IFS TEXWEAR Extension)

631, KUTUBPUR, FATULLAH, NARAYANGONJ
(23.6471165, 90.5020197)
19 December 2022

Observations

Fig.: Punching ratio from SAFE Model

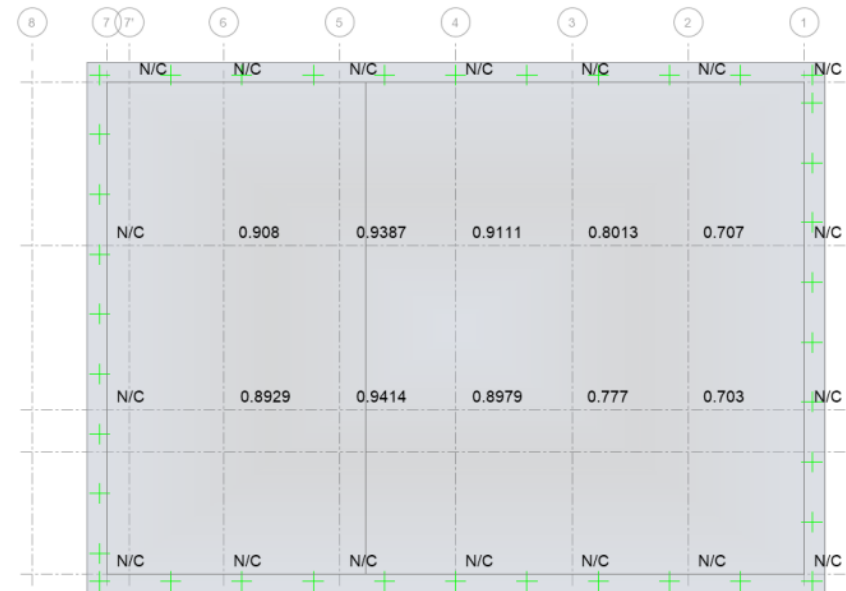
Flexural and punching adequacy of mat foundation has been checked using SAFE model.

Foundation punching stress in design report

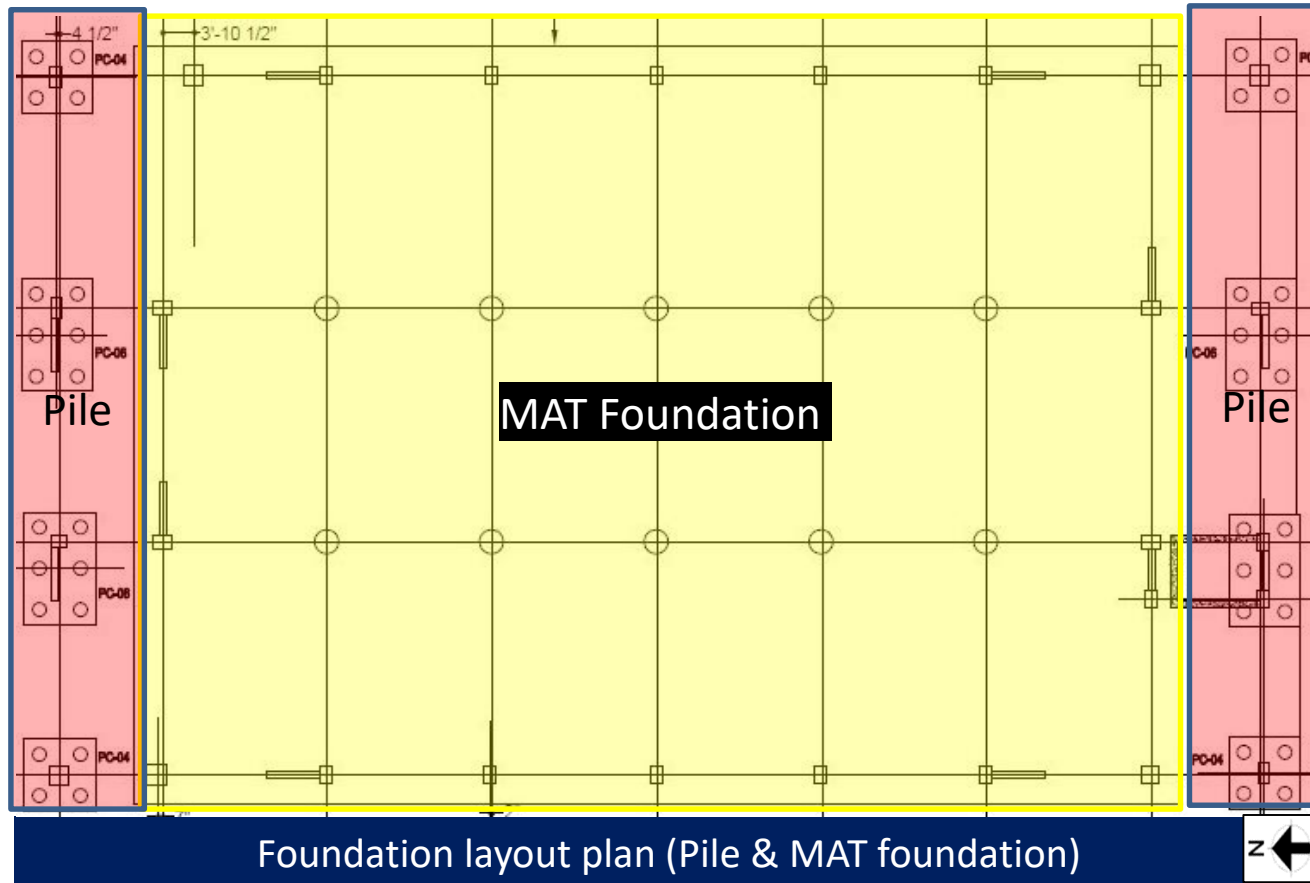
Both shallow and deep foundation constructed in the structure. Building engineer is required to check the allowable settlement of the foundations and incorporate it in the design report.

6th floor beam layout (two way slab)

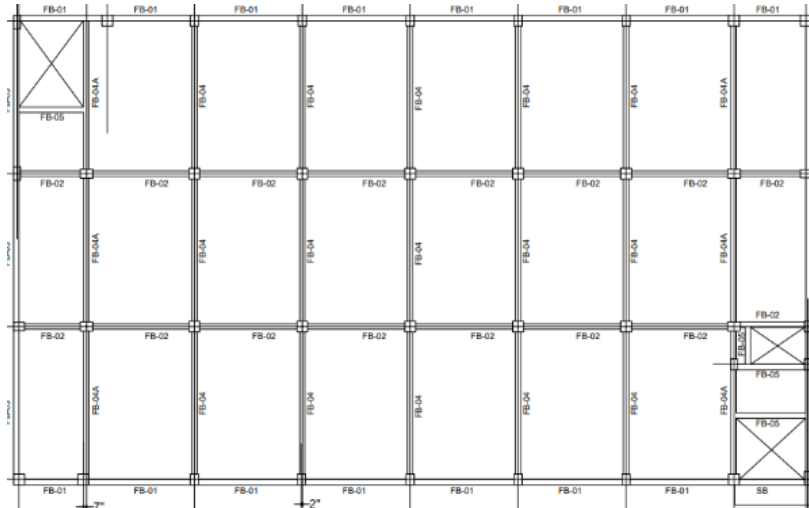
During inspection 6th floor beam layout was found not matched with as built drawing. Secondary beam was found in 6th floor level which was not shown in drawing. The building engineer is required to survey the structure and update the as built drawings accordingly.
